Re: The Park at Beaver Brook – Campanelli Response to Rebecca Verner's Comments

We write in response to comments from Planning Board Chair Rebecca Verner on the draft OSCD Special Permit Decision that were provided to Campanelli on 10/17/2025.

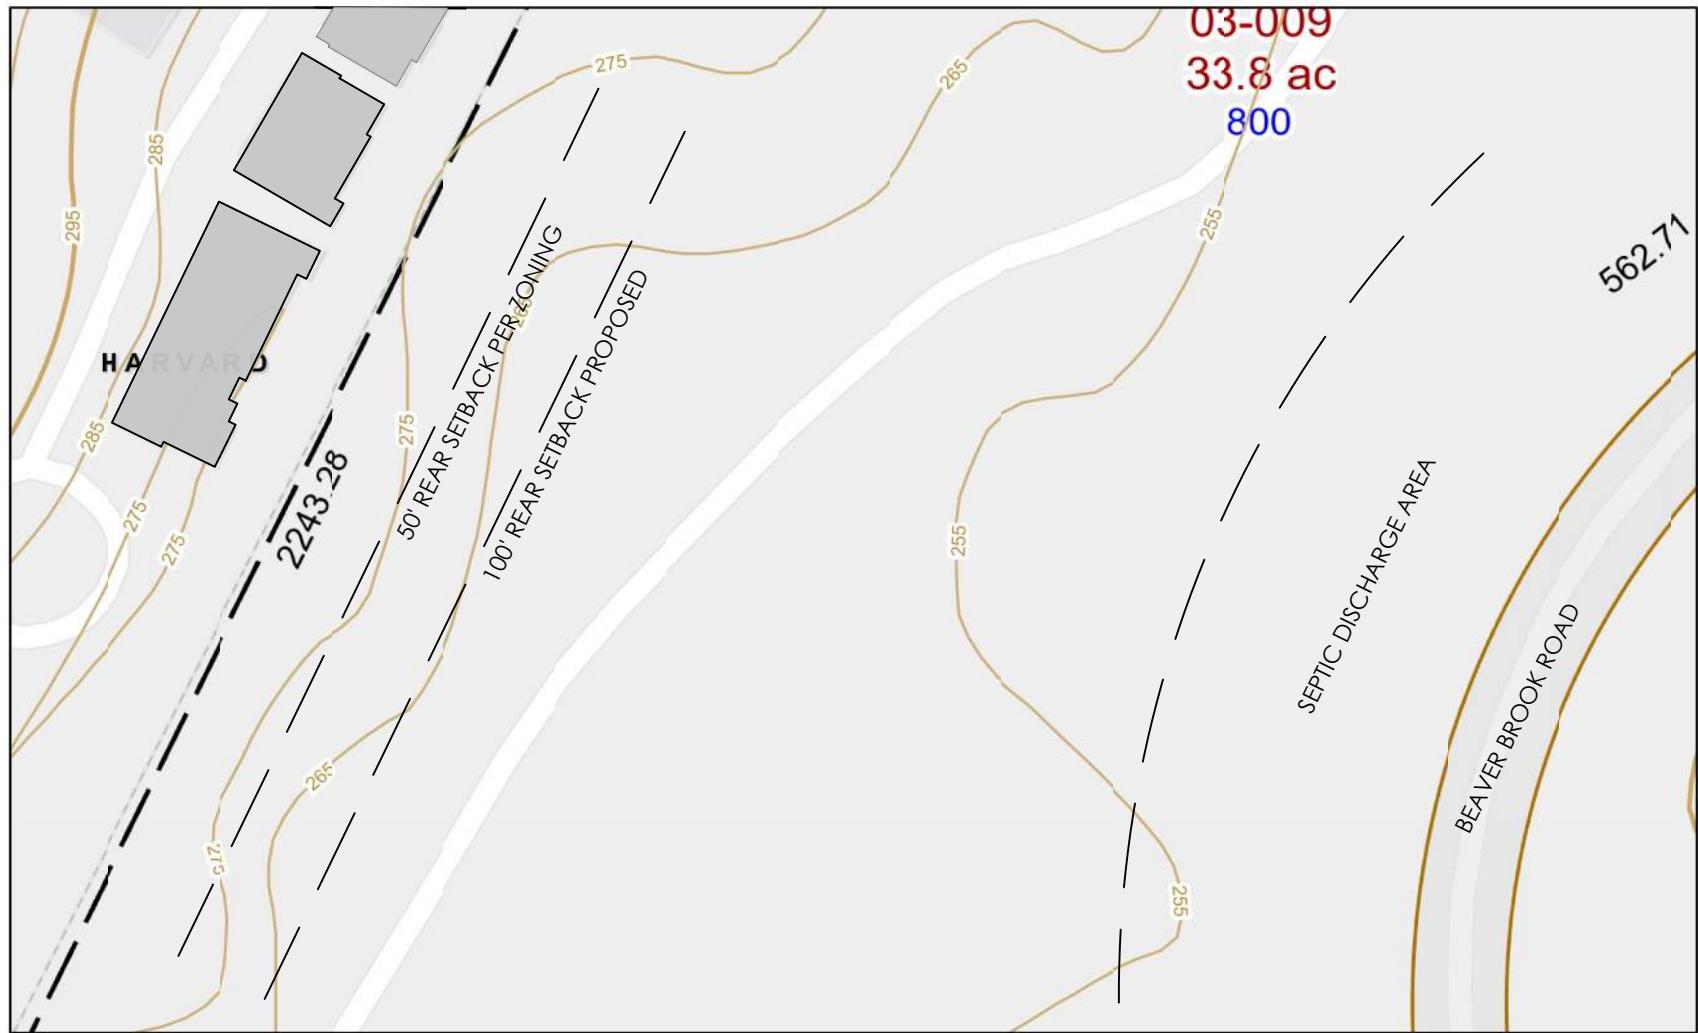
1. The residential development will be at the exact same elevation as the application proposal in front of us. It feels burdensome to the residential development to be looking right into the building at eye level. Reduction of height on the three buildings on 800 to 35'.

The Trail Ridge Condominium buildings and the proposed Lot 800 buildings are not at the same elevation. As shown on the attached topographical there is an approximate 23' +/- grade change between Lot 800 and the Trail Ridge Condos (Proposed Dev. 255 +/-, Trail Ridge 278' +/-). In addition, as illustrated in the attached Section (Exhibit 1), the residential development will not be looking right into the proposed Lot 800 buildings at eye level. Moreover, in addition to the proposed 100' setback (which exceeds what is required by zoning), there is an existing dense vegetated buffer in between the two lots, which provides significant screening. Further, as previously discussed with the Board, the proposed maximum height of the buildings complies with zoning. Appropriate mitigation of visual impacts on adjacent properties, if any, from future buildings on Lot 800 will be addressed during Site Plan Review of those buildings.

GENERAL WILDLIFE MOVEMENT AT LOT 800 THROUGH VEGETATED AREAS (Proposed Development)

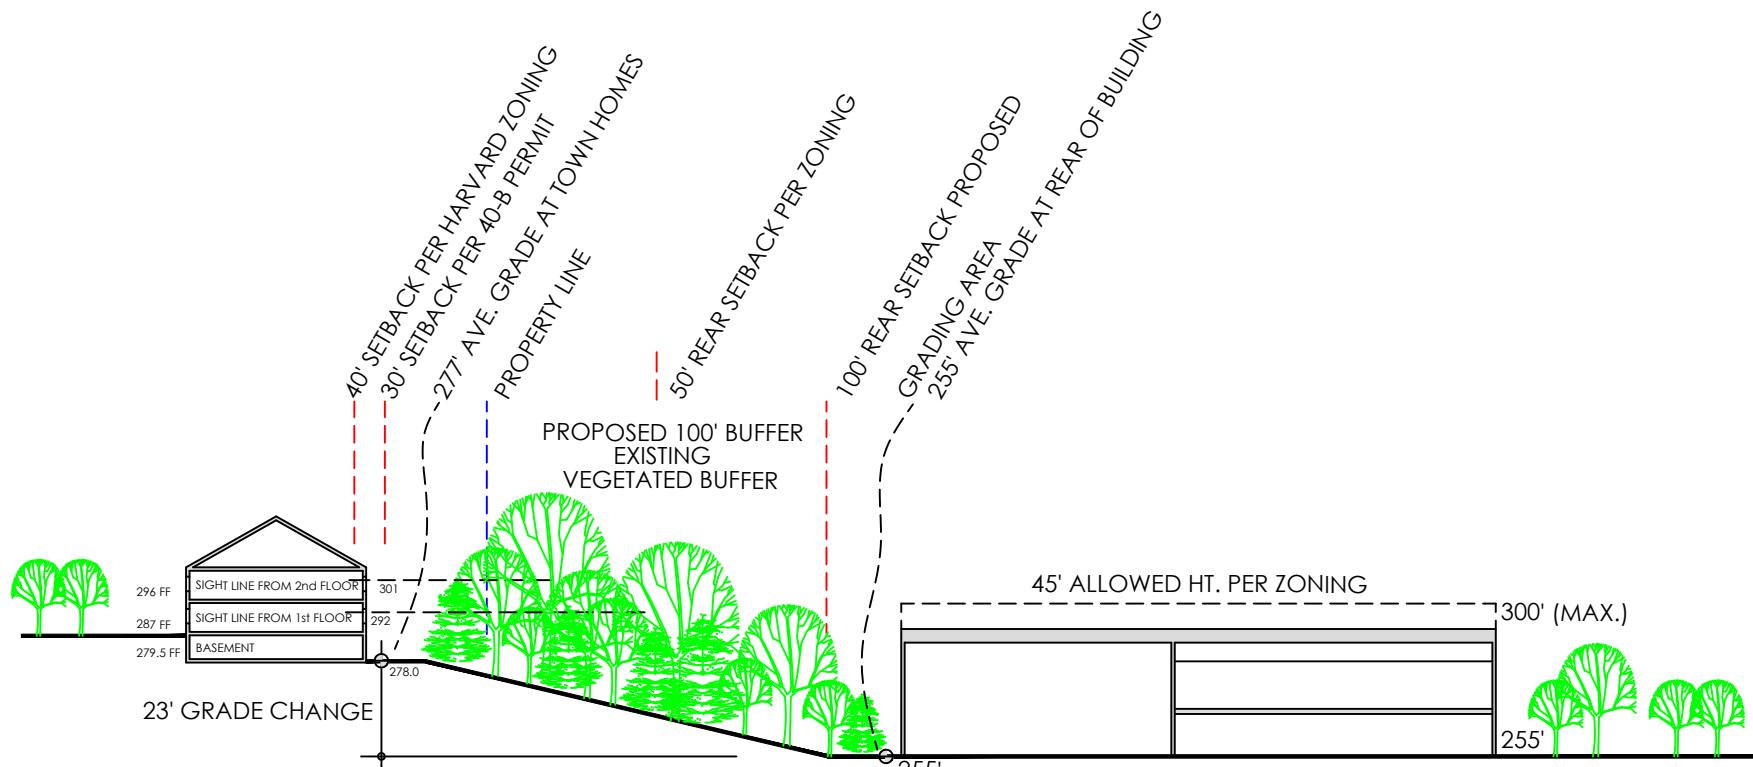
2. I would like to see a contiguous protected wildlife grassland corridor that connects to the surrounding woodlands to the rear of the buildings. This corridor shall be maintained as a native grassland habitat to support wildlife and birds.

3. *Contiguous wildlife grassland corridor map should be provided to the board.*

We are proposing an approximately 100-foot-wide wooded wildlife corridor to the rear of the buildings on Lot 800. This wooded corridor would serve as a visual buffer to the north abutters and would also serve as a beneficial east-west wildlife corridor in the northern portion of the site. Grassland birds do not require such a corridor, as they fly between nesting and foraging habitats. Moreover, these birds generally prefer open areas of suitable habitat at least 4 acres in size located away from forest field edges for nesting rather than linear, narrow

corridors to avoid predation. Mammals, reptiles, and amphibians prefer to move through cover rather than through open areas to limit predation. As such, it is more ecologically beneficial to maintain the current woodland wildlife corridor in its current location, while focusing on Lots 16 and 17 for the creation of a new grassland habitat. .

- As shown on [Attachment], the project provides a contiguous wildlife corridor that connects the site to other adjacent natural resource areas in Boxborough and Harvard. In contrast to wildlife corridors, grasslands primarily serve bird populations, such that corridors are not the preferred configuration. Indeed, grasslands work best when they are square or circular in shape and open and are a minimum of 4 acres in size; meanwhile, a corridor provides a linear area, which is less desirable to these species. To best serve bird species, Campanelli is providing a 10 acre +/- grassland habitat on Lots 16 and 17.
